INTENT
INSTRUCTION TEMPORARY CHANGE

TCN - 1

INSTRUCTION NO. PDB-P0001	REV. 2	INSTRUCTION TITLE Core Operating Limits Report for the Perry Nuclear Power Plant, Unit 1 Cycle 5 (Reload 4)	ADMIN. USE ONLY <div style="text-align: center; font-size: 2em; color: gray;">INFORMATION ONLY</div>
CANCELS TCN(S): NA			
LIST EACH ATTACHED PAGE 3, 4, 5, 6, 13

TITLE: COPE OPERATING LIMITS REPORT FOR THE PERRY NUCLEAR POWER PLANT,
UNIT 1 CYCLE 5 (RELOAD 4)

Figure 3.2.1-1

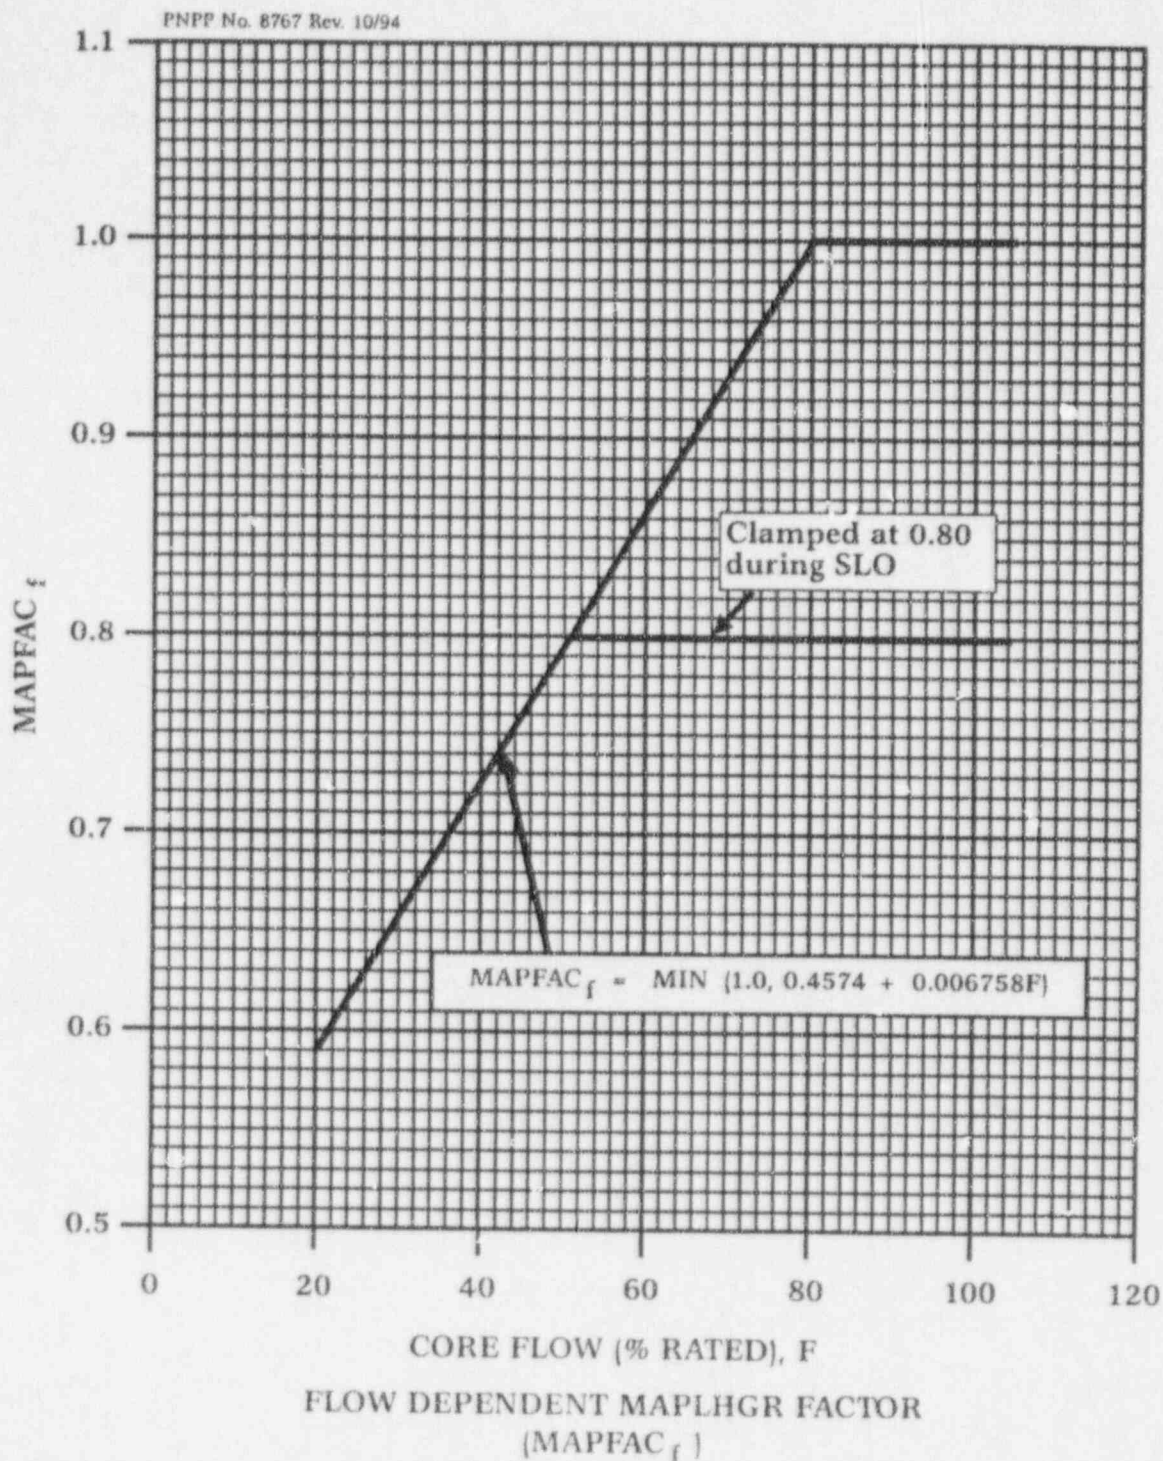
Incorporate T.S. Amendment 61, Single Loop Operation. Specifically, the power and flow dependent MAPLHC factors are limited to 0.80 during single loop operation.

Figure 3.2.2-1

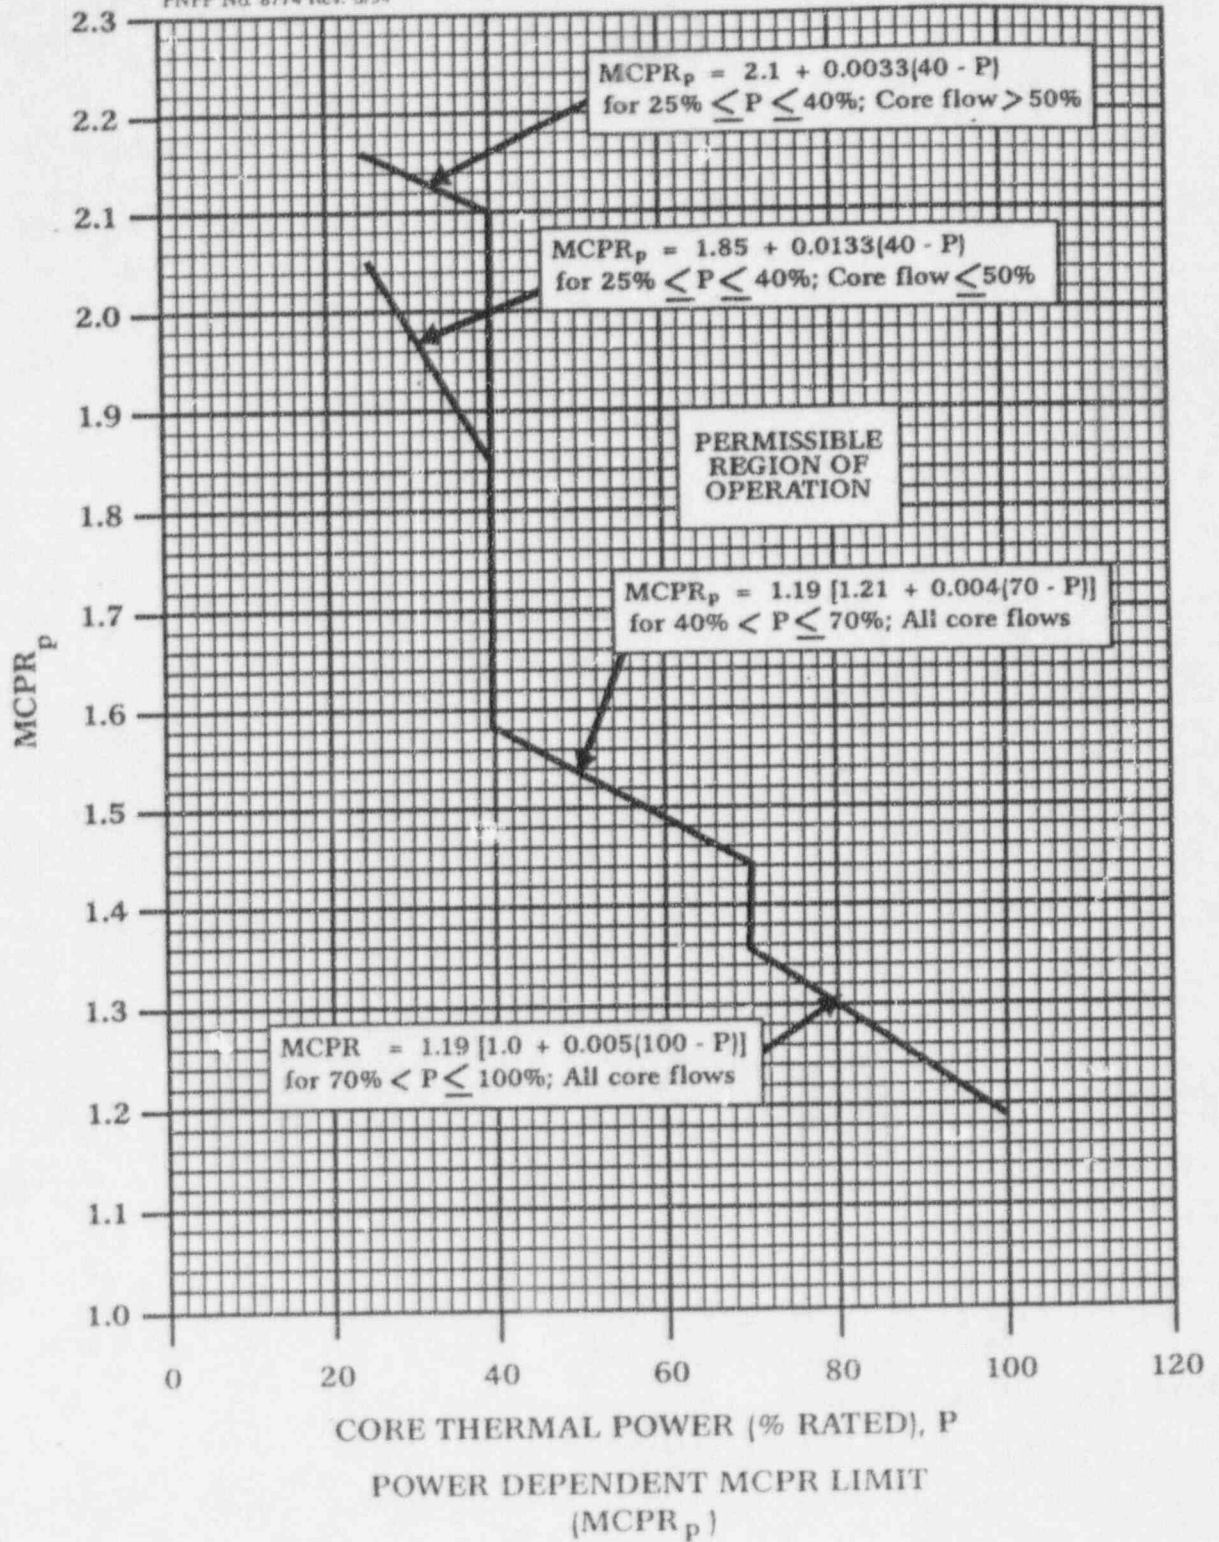
Planned reduction of rated feedwater temperature from nominal rated feedwater temperature is not permitted during plant operation with the reactor recirculation system in single loop operation. TC-1
